UNITED STATES PATENT AND TRADEMARK OFFICE

APPLICATION NO.	FILING DATE	FIRST NAMED INVENTOR	ATTORNEY DOCKET NO.	CONFIRMATION NO.
10/537,790	06/06/2005	Daniel A Silber	US020623 US	6668
24737	7590	01/19/2006	EXAMINER	
PHILIPS INTELLECTUAL PROPERTY & STANDARDS P.O. BOX 3001 BRIARCLIFF MANOR, NY 10510			HARVEY, JAMES R	
			ART UNIT	PAPER NUMBER
			2833

Office Action Summary

DETAILED ACTION

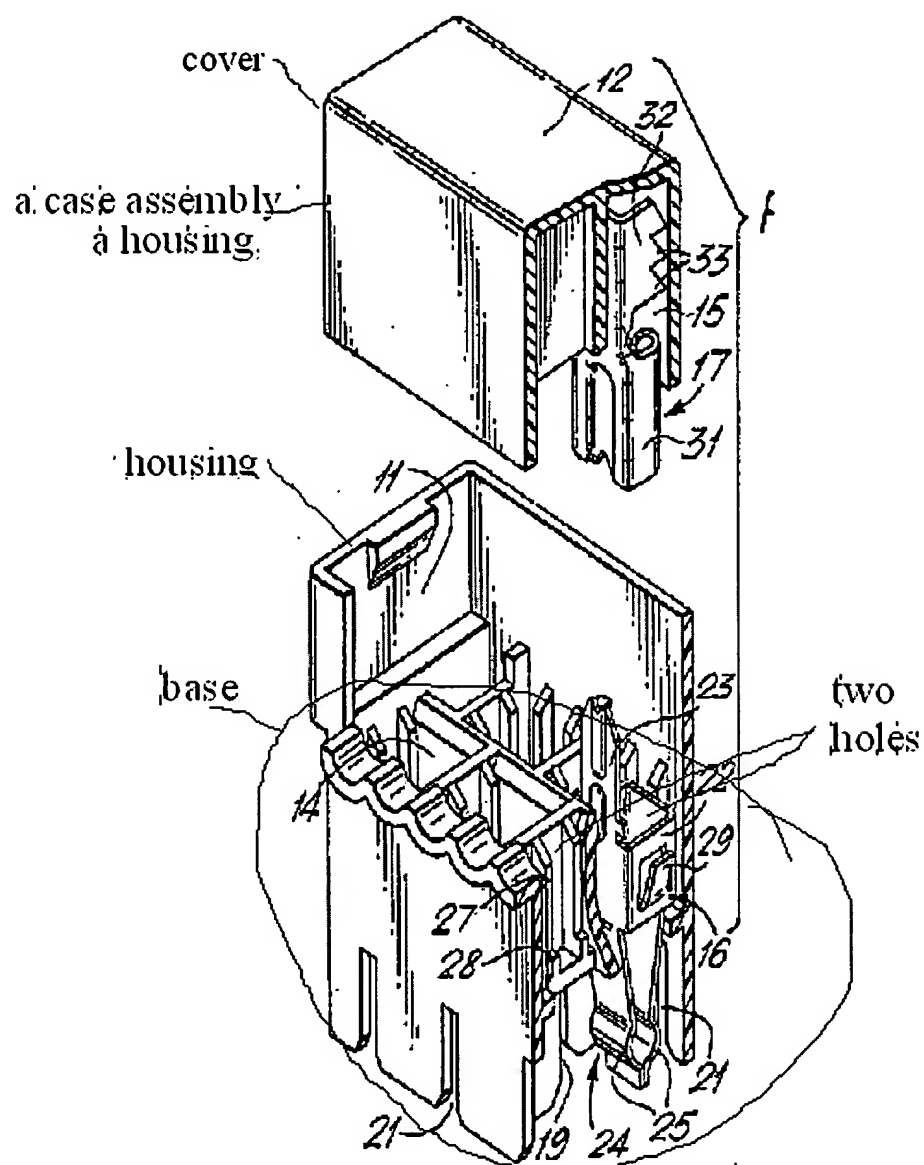
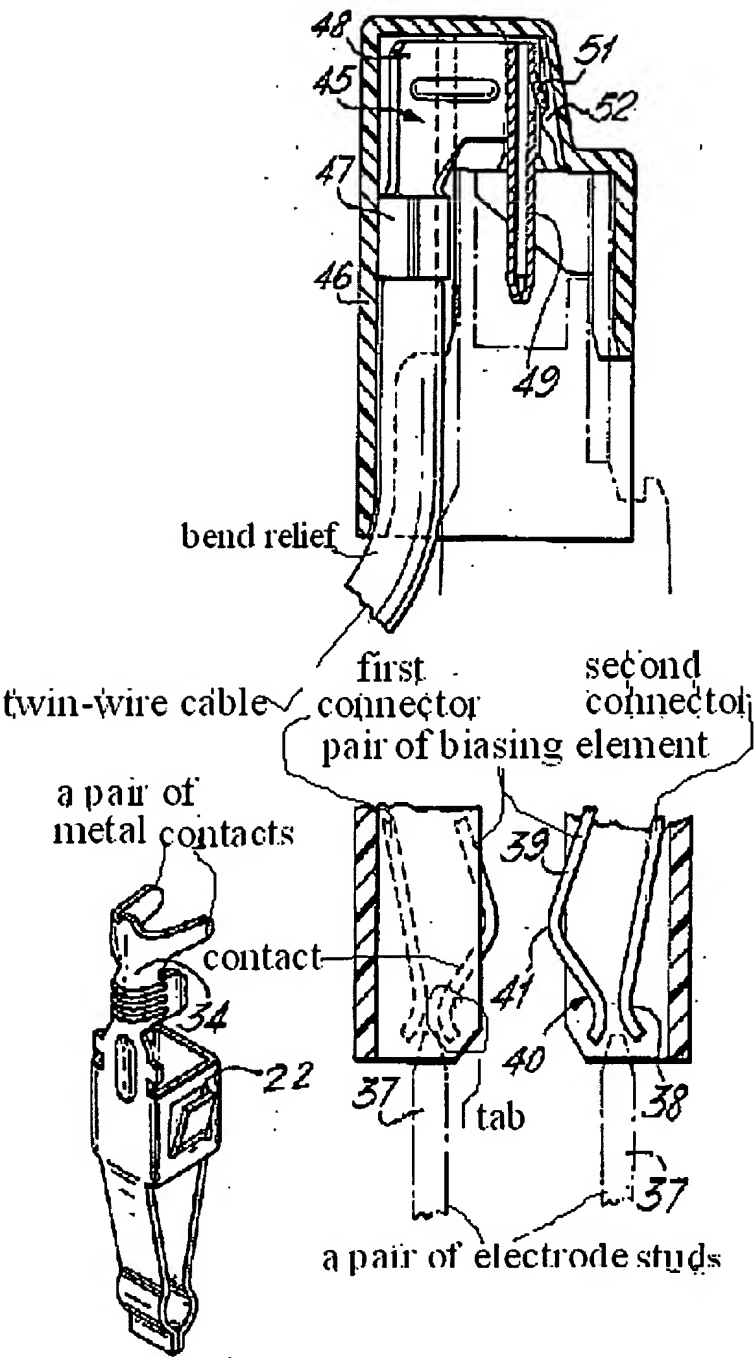
-- In reference to Claim(s) 1, Teagno shows (see examiner's figure)

a double-electrode connector housing (see examiner's figure) comprising a base (see examiner's figure) having two holes (see examiner's figure) therein of predetermined diameters arranged at predetermined location in the housing, with a first of the two holes associated with a first connector (see examiner's figure) and a second of the two holes associated with a second connector (see examiner's figure) of the double-electrode;

a pair of biasing elements (see examiner's figure) arranged along an inner surface (see examiner's figure) of the housing;

a case assembly comprising a housing (see examiner's figure), twin-wire cable (see examiner's figure), and a pair of metal contacts se , wherein each one of the pair of metal contacts is crimped to one of a first conductor and second conductor of the twin-wire cable.

In particular reference to the recitation “is adapted for biasing against one of a pair of electrode studs inserted in a respective hole of the two holes in the housing” is seen to be for the intended use of the claimed structure and is given little patentable weight, since it has been held a recitation with respect to the manner in which a claimed apparatus is intended be employed does not differentiate the claimed apparatus from a prior art apparatus satisfying the claimed structural limitations. Ex parte Masham, 2 USPQ2d 1647 (1987). Further, the recitation is not seen to claim any structure that prevents the reference from being used for the same purpose as the intended use recitations of the claim.

contact of each of the biasing elements comprises a tab (see examiner's figure).

the case housing includes a cover and a base, and both are comprised of injection-molded plastic.
